# ADDENDUM

**PROJECT: Clovis Landmark Square  
Senior Activity Center and Transit Center**

**ADDENDUM#: 02**

**PUBLISHED DATE: October 30, 2020**

**ADDENDUM #2**  
REVISIONS TO PATIO EXIT WALKS & GATES  
10-27-20 J.S.

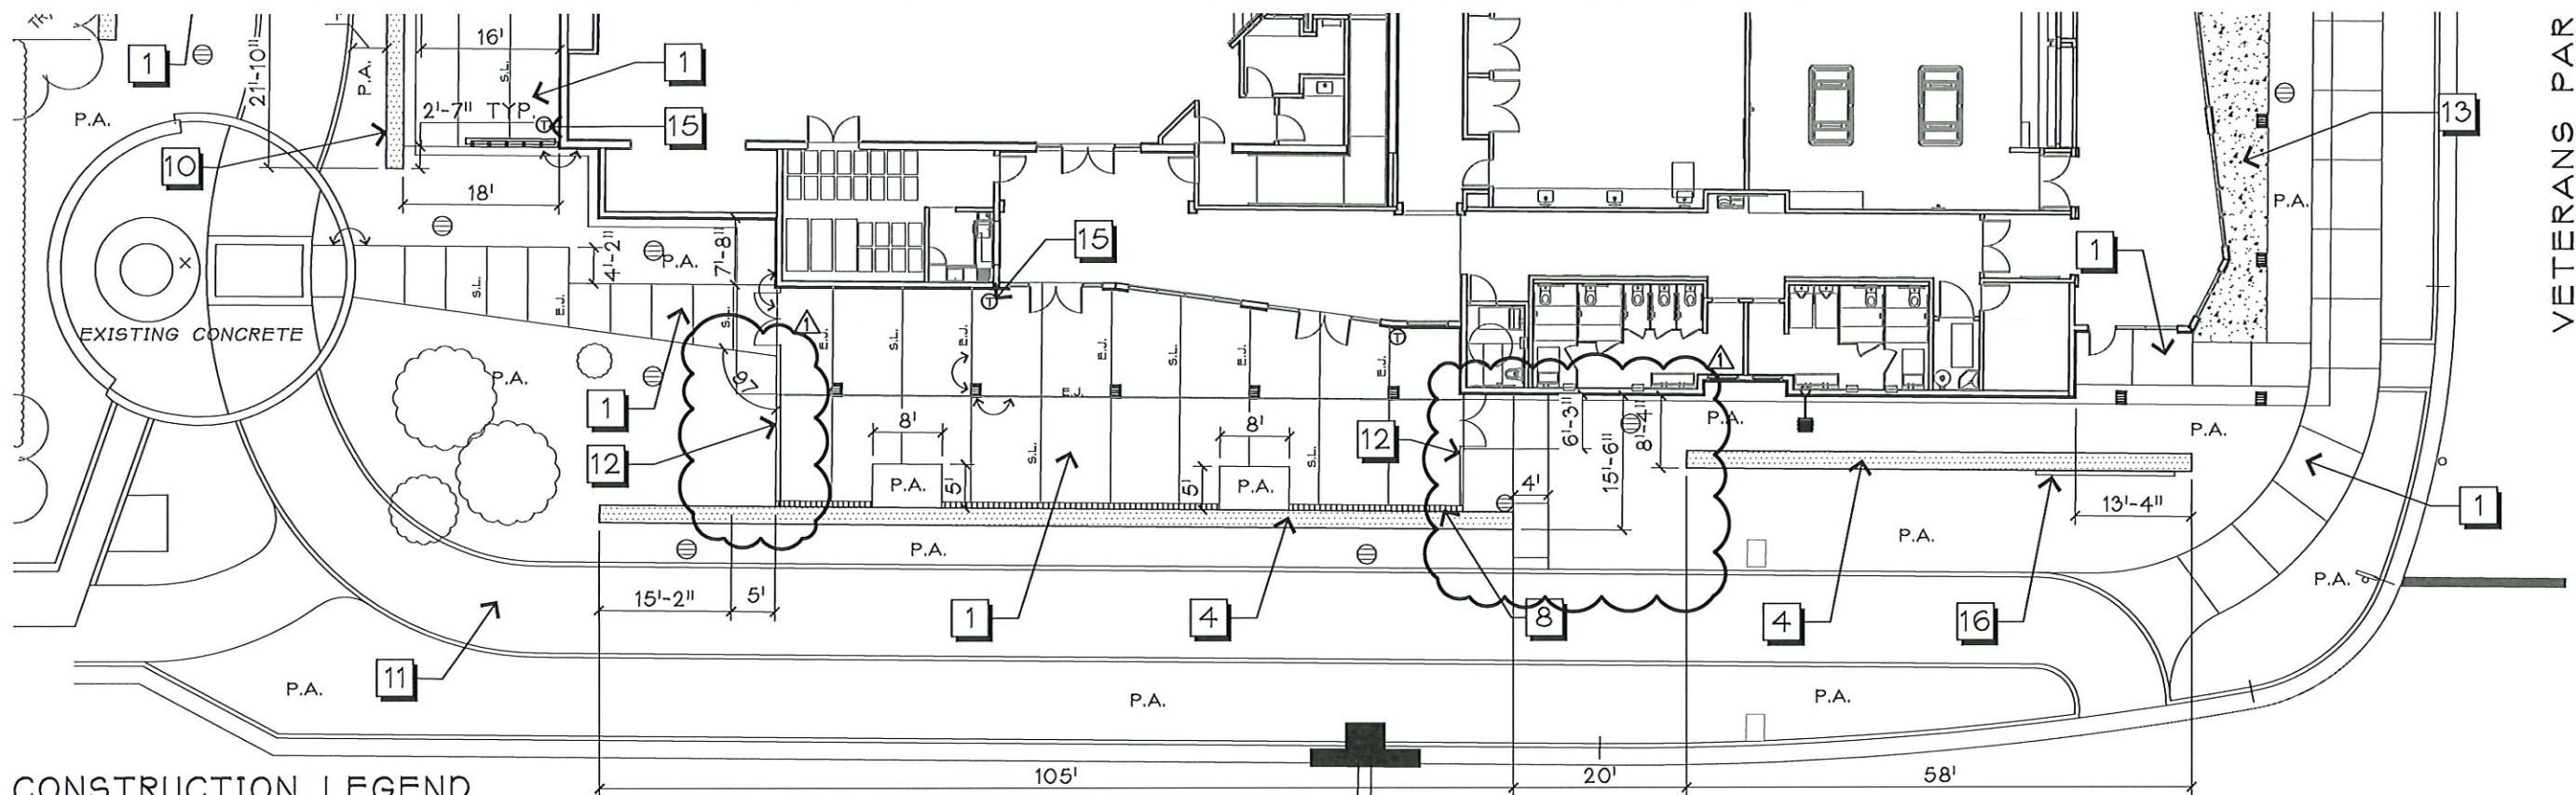
- a. Refer to sheet 17 of 24, Construction Plan in the On-Site Improvement Plans – Add sheet **1 of 3, Addendum #2** for exhibit with revisions to Construction Plan.

**ROOF FRAMING PLAN**  
 SCALE: 1/8" = 1'-0"

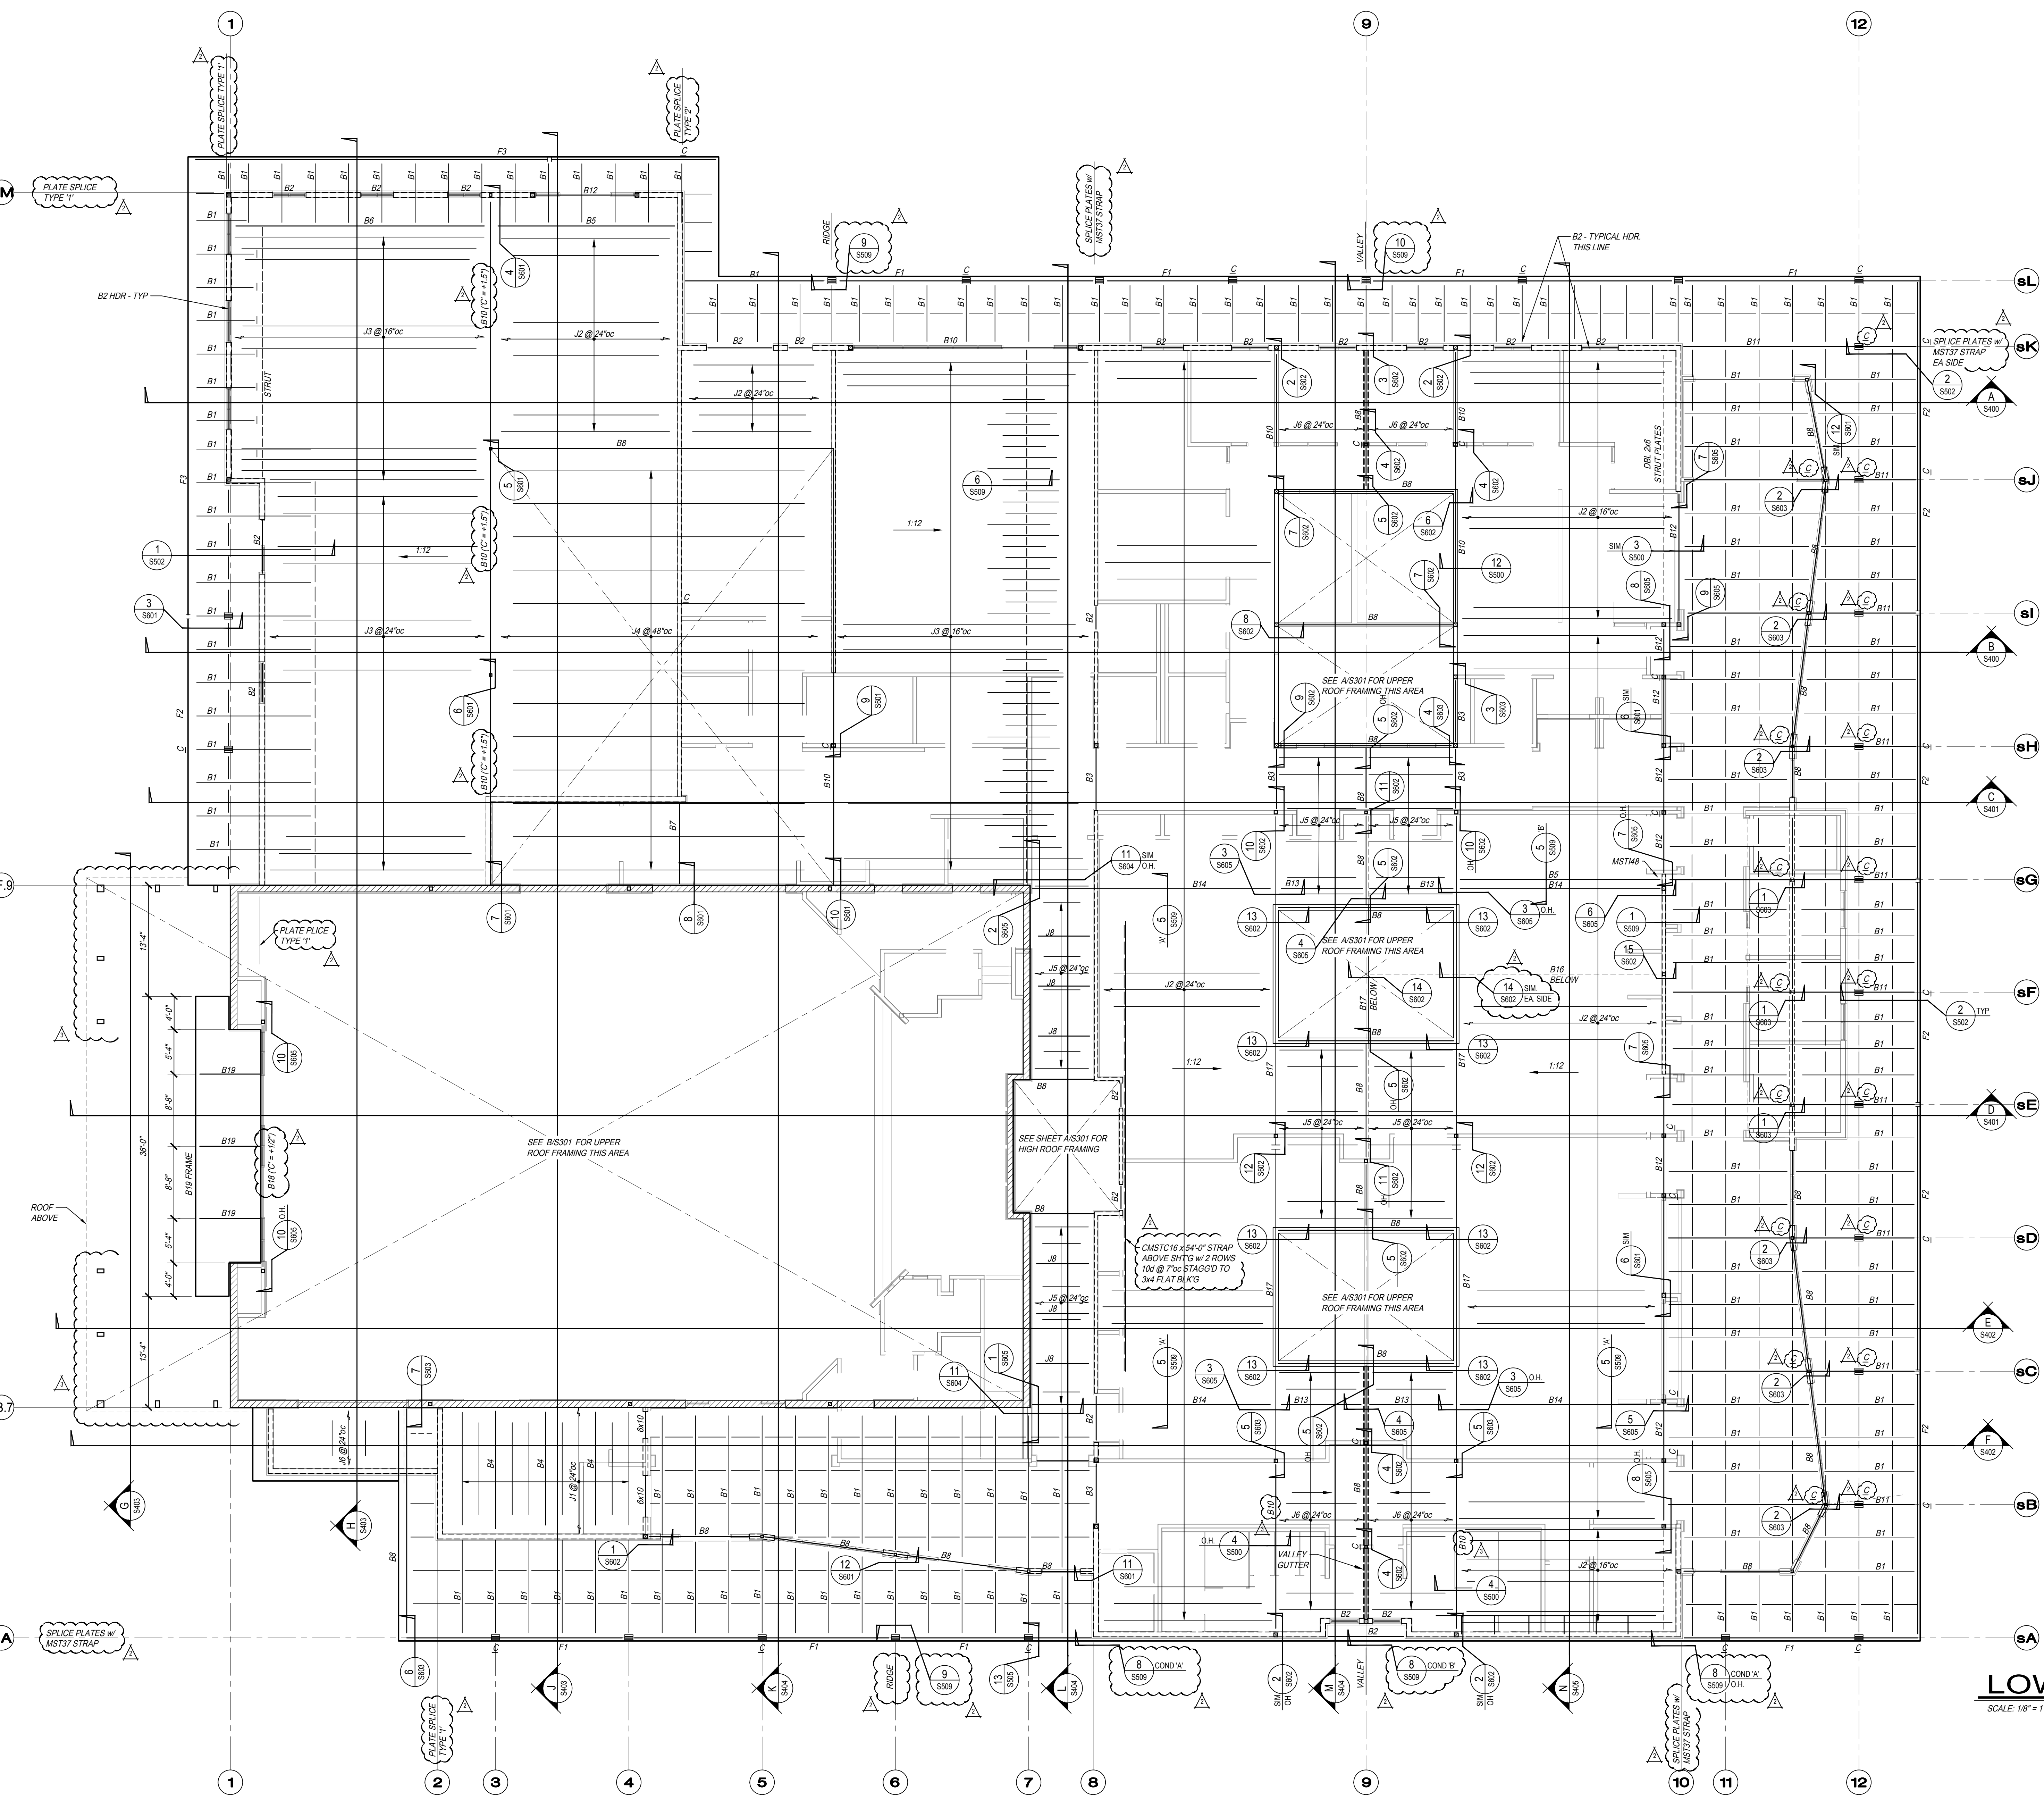
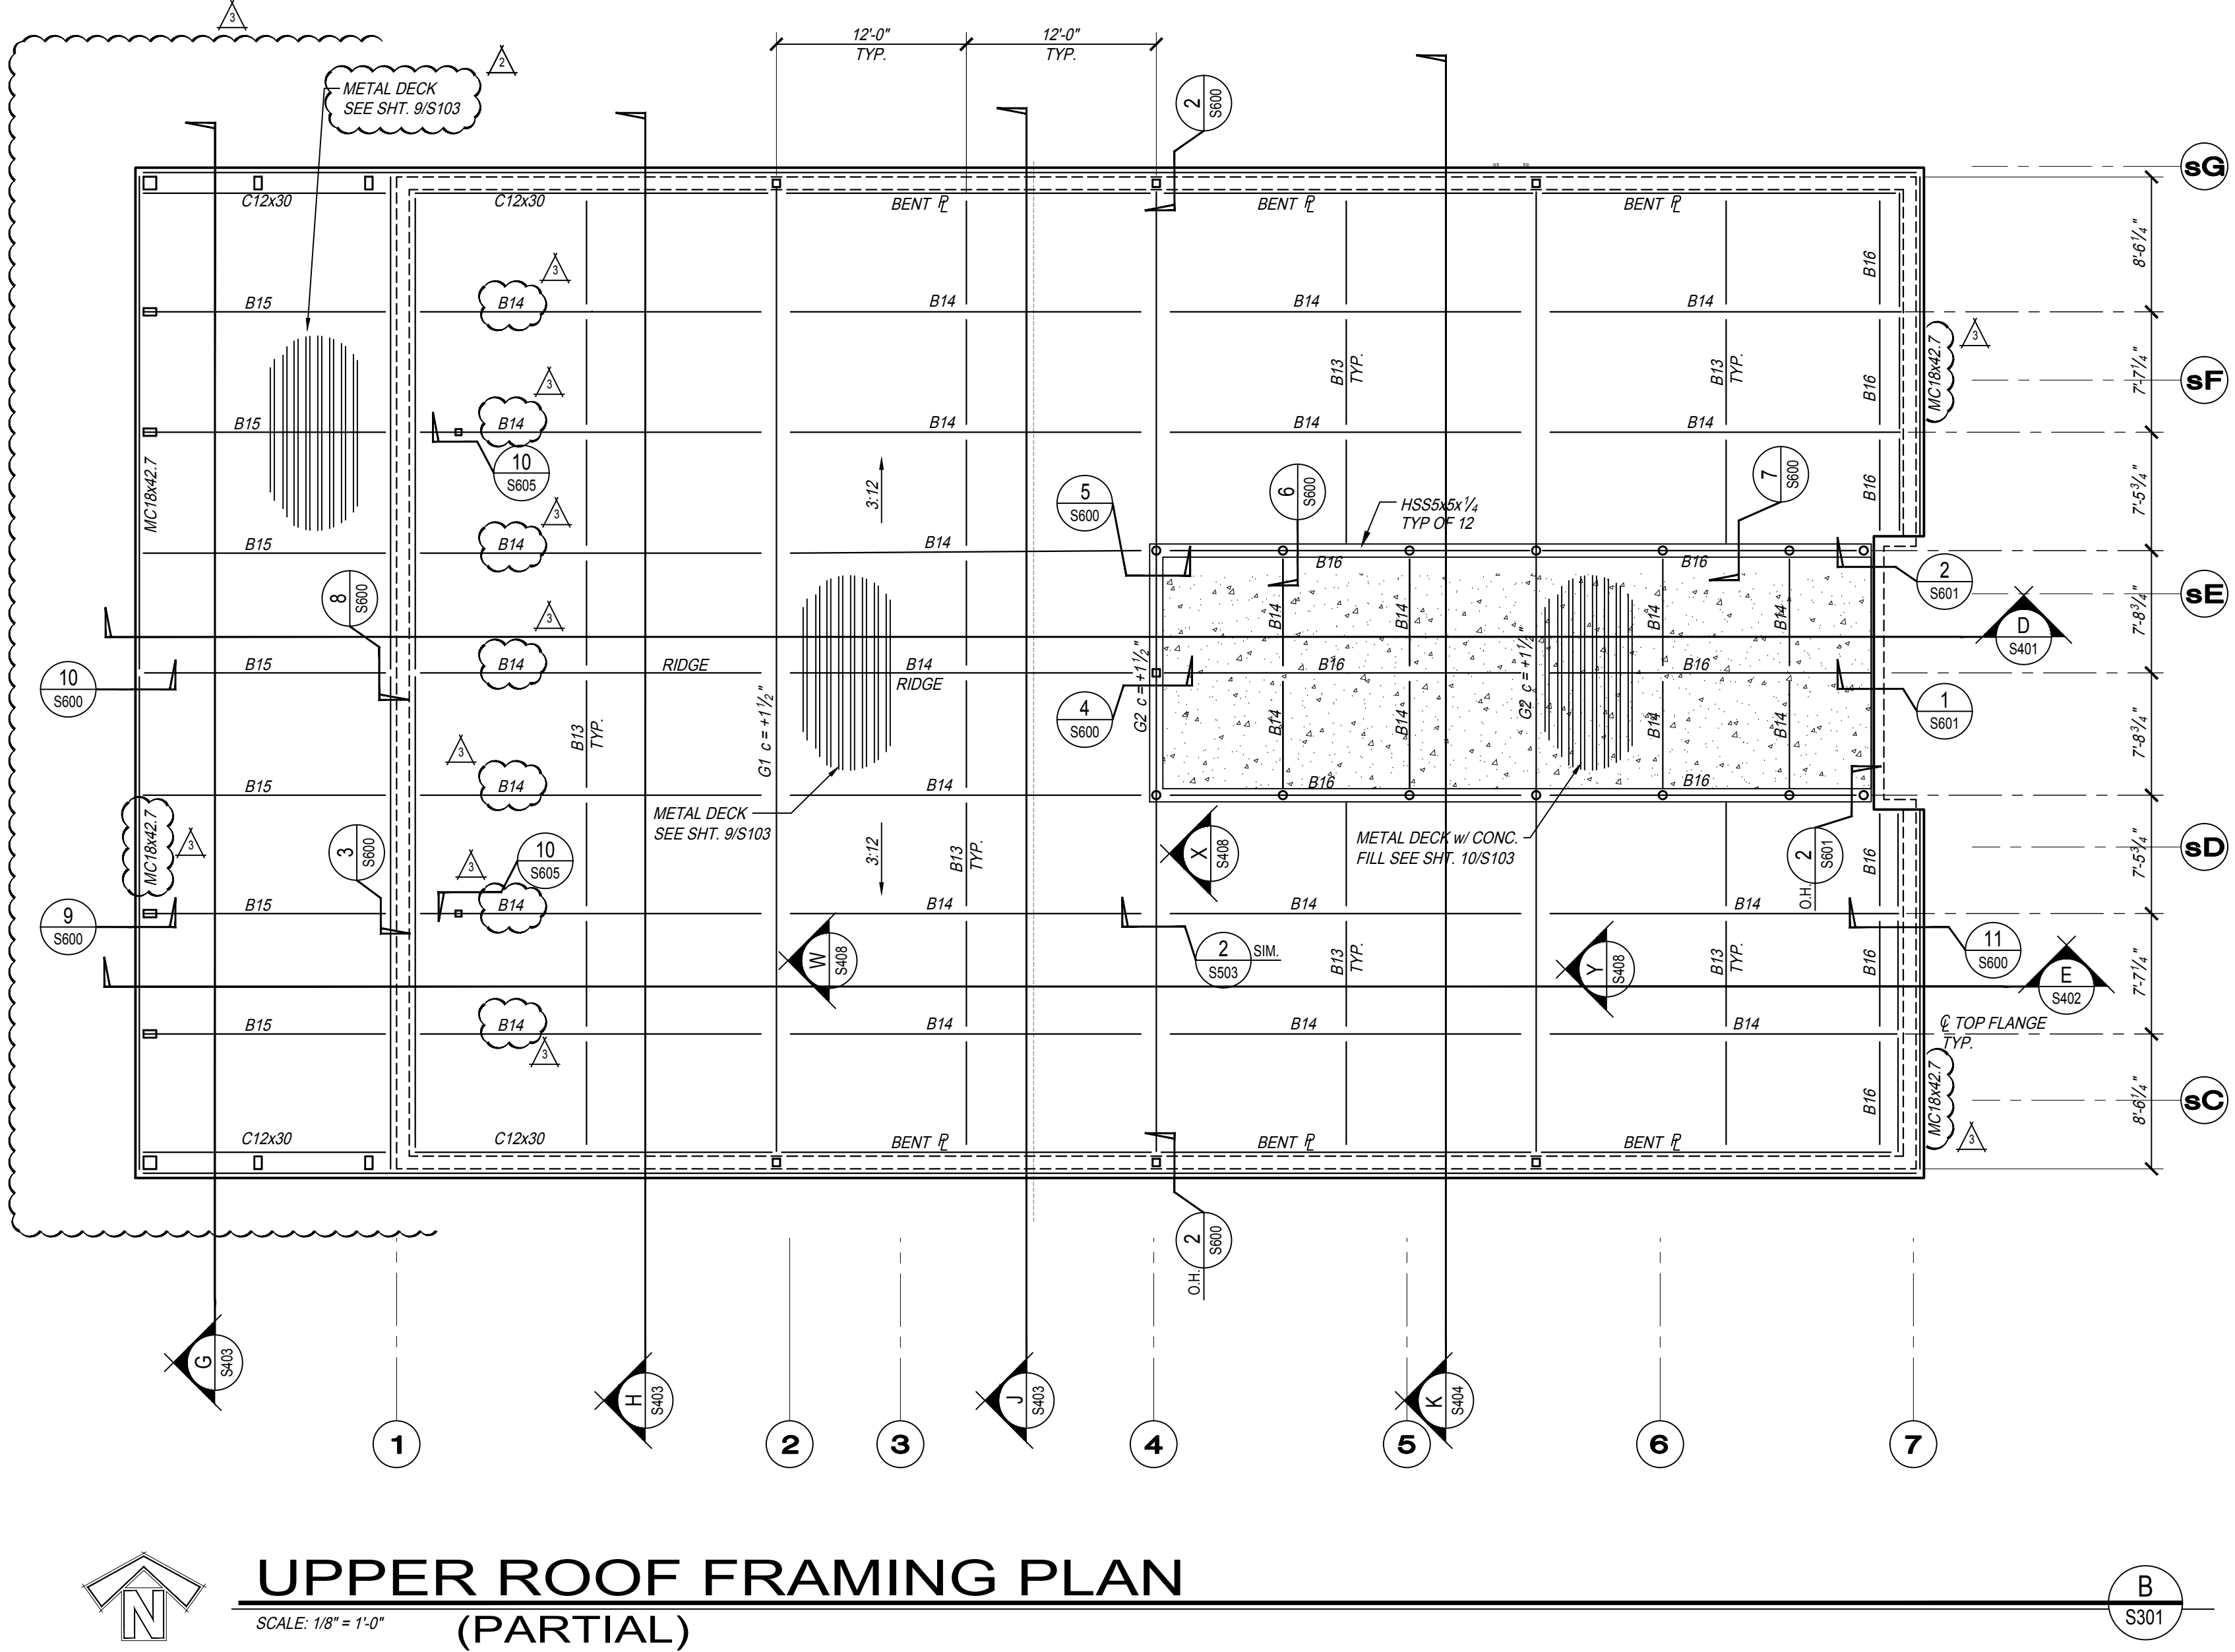
- a. Omit sheet **AD1-S300, Senior Activity Center-Roof Framing Plan** and replace with **AD2-S300, Senior Activity Center-Roof Framing Plan** attached. The following changes have been made:
  - i. Revised beam sizes each side of Grid 9 and north of Grid sA.
